UNITED STATES PATENT AND TRADEMARK OFFICE

APPLICATION NO.	FILING DATE	FIRST NAMED INVENTOR	ATTORNEY DOCKET NO.	CONFIRMATION NO.
10/536,576	02/06/2006	Piotr Szwaykowski	TROLOGY 02.02	9931
27667	7590	03/26/2010		
HAYES SOLOWAY P.C. 3450 E. SUNRISE DRIVE, SUITE 140 TUCSON, AZ 85718			EXAMINER LEE, HWA S	
			ART UNIT 2886	PAPER NUMBER
			NOTIFICATION DATE 03/26/2010	DELIVERY MODE ELECTRONIC

Office Action Summary	Application No. 10/536,576	Applicant(s) SZWAYKOWSKI ET AL.	
	Examiner Hwa S. Andrew Lee	Art Unit 2886

DETAILED ACTION

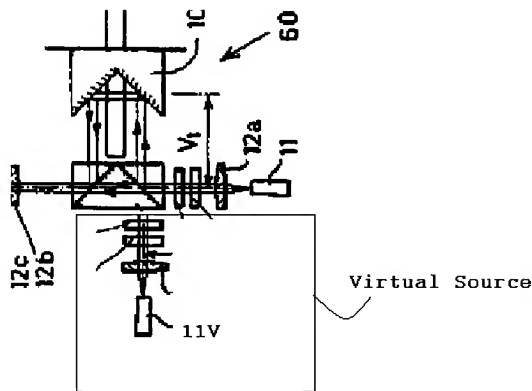
Kuchel show an interferometer for measuring optical phase differences (e.g. Figure 6) comprising
a source module (60) for generating mutually orthogonally polarized beams of light from spatially separated sources (please see diagram below showing how there is a source (11) and a virtual source (11V) created by the beamsplitter. The source (11) and virtual source (11V) are spatially separated);

an interferometry module (13-16) receiving said mutually orthogonally polarized and temporally synchronized beams from said source module, and having at least a reference object (14) and a test object (16) for interaction with said beams; and

a simultaneous phase shifting module (68) receiving a portion of said beams from said interferometry module for generating at least two phase-shifted (67b) interferograms substantially simultaneously from said beams.
